Certificate of Appropriateness
BAR #HST24-0049
614 Park Street, Tax Parcel 520184100
North Downtown ADC District
Owners/Applicants: Carrie & Kevin Burke
Project: Site alterations and courtyard parking

**City of Charlottesville
Board of Architectural Review
Staff Report
January 22, 2025**

Certificate of Appropriateness Application
614 Park Street, TMP 520184100; HST24-0049
North Downtown ADC District
Owners/Applicants: Carrie & Kevin Burke
Project: Site alterations and courtyard parking

2013 CONCEPT DIAGRAM

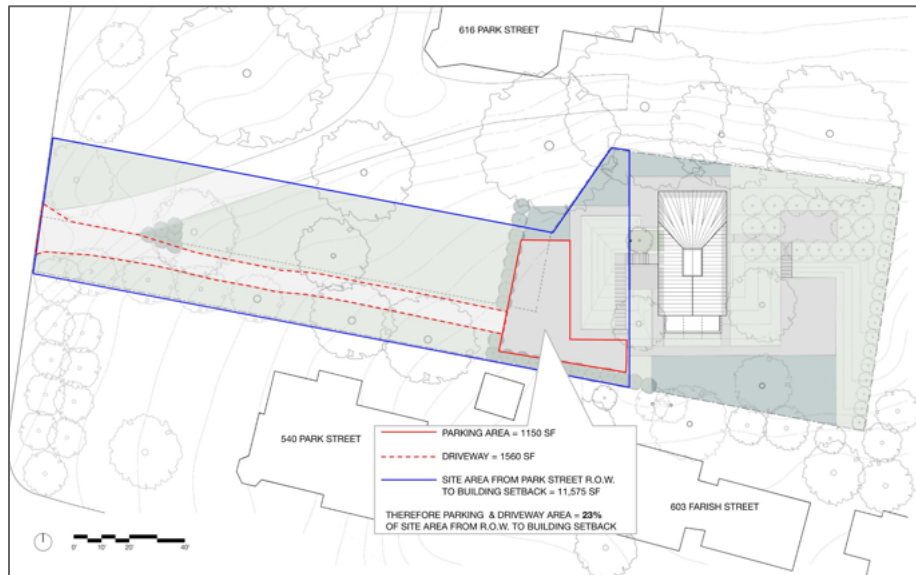
For single-family dwellings, parking may be located in any yard. Driveways and off-street parking areas, except in garages and carports, shall not exceed 25% of the lot area between the R/W and the building setback line. You should check the percentage.

That said, the BAR could further limit parking in front of a historic building in an ADC district. Given the siting of your home, I doubt they would have any objections to your plan for a courtyard parking area in front.
